Daylight and Sunlight Opinion

London Borough of Haringey

Hornsey Town Hall
The Broadway
London N8 9JJ

29 November 2017

Figure 2: Previous building on site (Bing Maps imagery dated 2012)

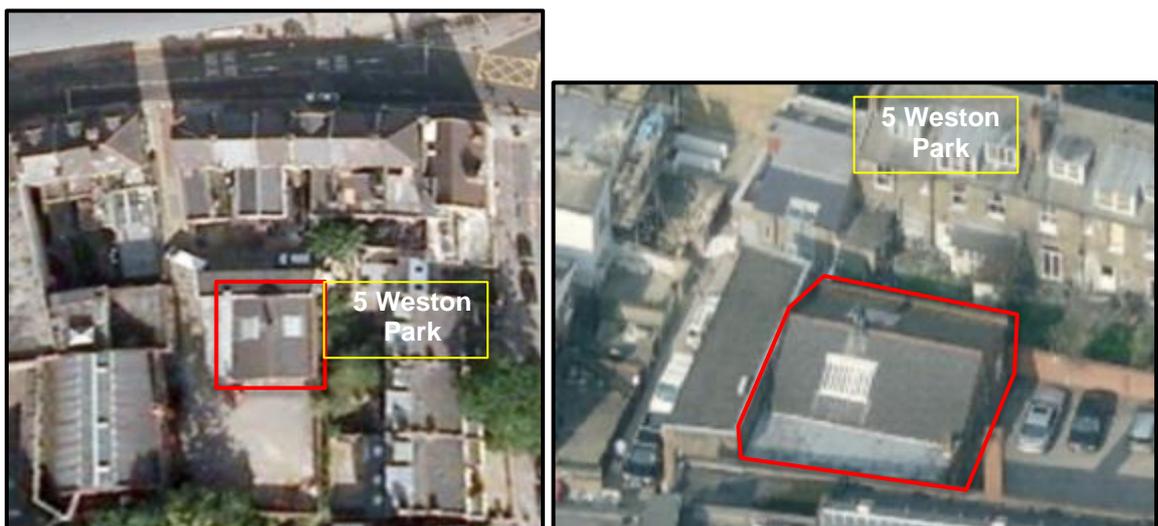
3.2.6 The overshadowing assessment of the garden shows a significant reduction in the sunlight availability on 21 March. The reduction is beyond the BRE Report guidance. The P2 Report has studied a comparison of the current site conditions with those that would exist with the Proposed Development in place. Two factors should be considered when assessing the significance of the impacts detailed in the assessment.

3.2.7 Firstly, a study of historic imagery (Figure 2 below) shows that a 2 storey building existed on part of the Proposed Development site adjacent to the boundary wall of 5 Weston Park. This building was removed in 2012. This building would have had a noticeable effect on the area of the garden that could receive direct sunlight on 21 March. It is likely that comparison with the sunlight amenity received pre 2012 would illustrate less change.

3.2.9 Given the urban context, the pre 2012 amenity and the comparative results with the Consented Development we would consider the effect on the overshadowing to be minor to moderate adverse.

Figure 3: Foliage adjacent to Prime Zone Mews B

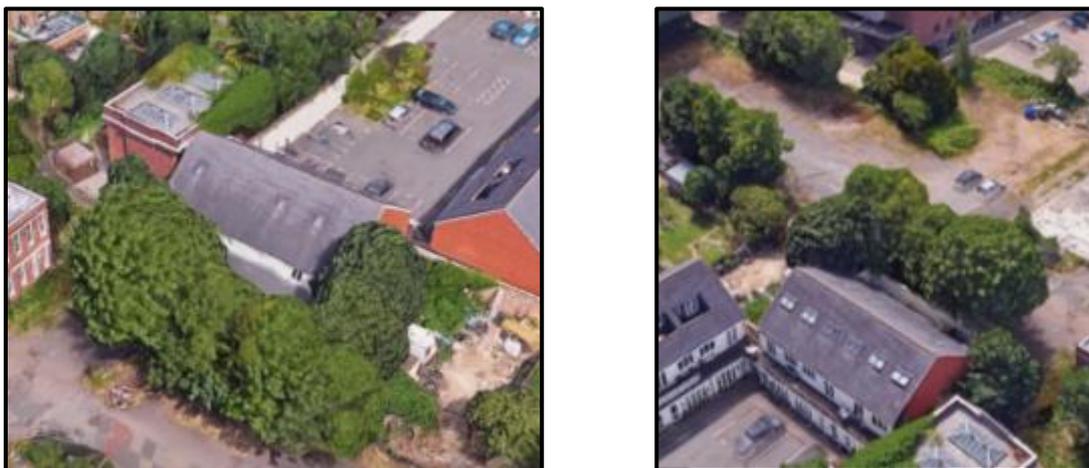
- 3.6.4 Study of the site shows that the current daylight and sunlight amenity to Prime Zone Mews B will see restrictions not accounted for in the P2 Report. Figure 3 below shows relatively dense foliage and a mature tree along the boundary with the Proposed Development site. While there is no provision within the BRE Report to allow for the effects of this vegetation it would have a practical effect on the current natural light amenity experienced by these properties.

- 3.6.5 We understand that this foliage will be removed as part of the Proposed Development. Whilst the Proposed Development will be greater in height than the vegetation it does step back from the boundary. Overall, it is probable that the VSC, DD and APSH values with the Proposed

Development in place will more closely resemble those currently experienced with the vegetation in place.

3.6.7 Taking the above factors into account we would consider the effects on Prime Zone Mews B to be moderate adverse.
